**Staff Report**  
**City of Richmond, Virginia**

**Commission of Architectural Review**

COA-103317-2021	<b>Final Review</b> <b>Meeting Date: 12/21/2021</b>
<b>Applicant/Petitioner</b>	Forrest Frazier
<b>Project Description</b>	Construct four attached, single-family dwellings on a vacant lot
<b>Project Location</b>	
<b>Address:</b> 618-620 Chamberlayne Pkwy.	
<b>Historic District:</b> Jackson Ward	
<b>High-Level Details:</b> <ul style="list-style-type: none"> <li>The applicant proposes to construct four new attached dwellings. Each unit will have an entry on the front façade.</li> <li>The proposed building will be three stories tall (recessed third story).</li> <li>Four Parking spaces are proposed in the rear, along the alley.</li> <li>This submission differs in design from a previously approved application for this property.</li> </ul>	
<b>Staff Recommendation</b>	Approval, with Conditions
<b>Staff Contact</b>	Eva Campbell, <a href="mailto:eva.campbell@RVA.gov">eva.campbell@RVA.gov</a> , 804-646-7550

Figure 10. 619-625 St. James Street. Attached residences with a staggered setback and varying cornice detail.

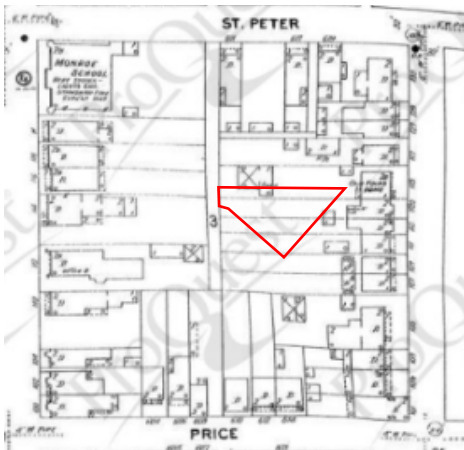
Guideline Reference	Reference Text	Analysis
Siting, pg. 46, #2-3	<i>New residential infill construction should respect the prevailing front and side yard setback patterns of the surrounding block. The minimum setbacks evident in most districts reinforce the traditional street wall.</i>	The site is triangular in shape and the buildings are located on the site to address the irregular shape of the parcel.
	<i>New buildings should face the most prominent street bordering the site.</i>	The proposed dwellings face Chamberlayne Parkway, the primary street bordering the property.
Form, pg. 46, #1-3	<i>New construction should use a building form compatible with that found elsewhere in the historic district.</i>	<p>The proposed third floor setback is not a common form found in the district, but has been approved for new construction in the past.</p> <p>Staff notes that it is not uncommon in the district to have three story buildings with a flat roof form, or ones that utilize a faux mansard on the third floor.</p> <p>Each of the brick facades feature a recessed vertical course of bricks facing Chamberlayne Parkway. This vertical course of bricks visually separates each of the brick facades. Generally, front facades of existing buildings in the district are not separated by this feature. Staff recommends that the <u>vertical course of brick be removed from each of the brick facades</u> in order to create more uniform brick facades.</p> <p>A majority of the attached row houses in Jackson Ward are not visually separated by a recessed bay or differing material. While the individual brick facades of the new construction are generally in keeping with the width of residences in the district, staff notes that their separation with recessed bays clad in horizontal siding is not common. Staff notes that a majority of attached row homes in Jackson ward are visually separated using architectural elements such as front porches, varying cornice details, and occasionally a slight stagger in the setback of individual units. Staff recommends that the attached units</p>

be differentiated with elements that are more commonly found on attached row houses in the district. (See figure 10)
	<i>New residential construction should maintain the existing human scale of nearby historic residential construction in the district.</i>	The proposed structure is taller than surrounding residential construction in the district. Staff notes that the height of buildings in the district vary.
	<i>New residential construction and additions should incorporate human-scale elements such as cornices, porches and front steps into their design.</i>	Other residential row houses within the district utilize individual full-width front porches to define each individual building's façade and create a unifying, common feature, or one combined full-width front porch.  <u>Staff recommends that each unit utilize a full width, single-story, covered front porch.</u>
Height, Width, Proportion, & Massing, pg. 47, #1-3	<i>New residential construction should respect the typical height of surrounding residential buildings.</i>	The proposed is 2-story with a setback 3 <sup>rd</sup> story as opposed to the typical two stories of the surrounding residential buildings.
